No. 92-13

A. LEAKAGE BETWEEN EXHAUST PIPE AND GIMBAL HOUSING ASSEMBLY

71575

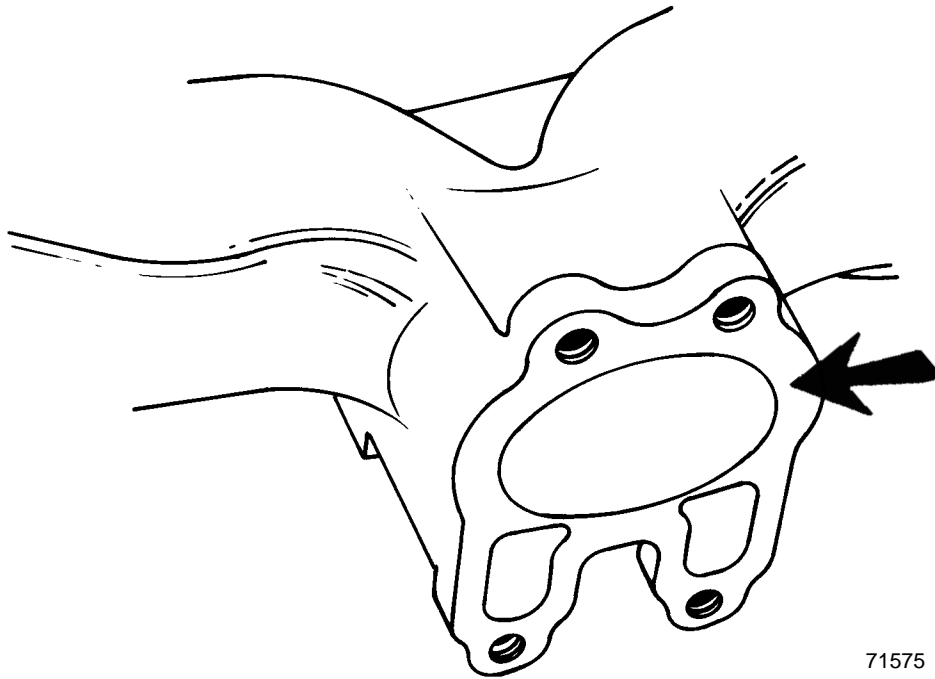
Paint build-up on mating surface of the exhaust pipe can prevent proper sealing of the exhaust pipe to the gimbal housing assembly. A poor seal may result in water and / or exhaust leaking into the engine compartment or bilge of the boat.

Check mating surface of the exhaust pipe (shown below) for paint runs ect. If an irregular surface is found due to paint build-up, Any paint runs on the flange surface at the exhaust pipe should be sanded off so the flange is smooth and will seal properly.
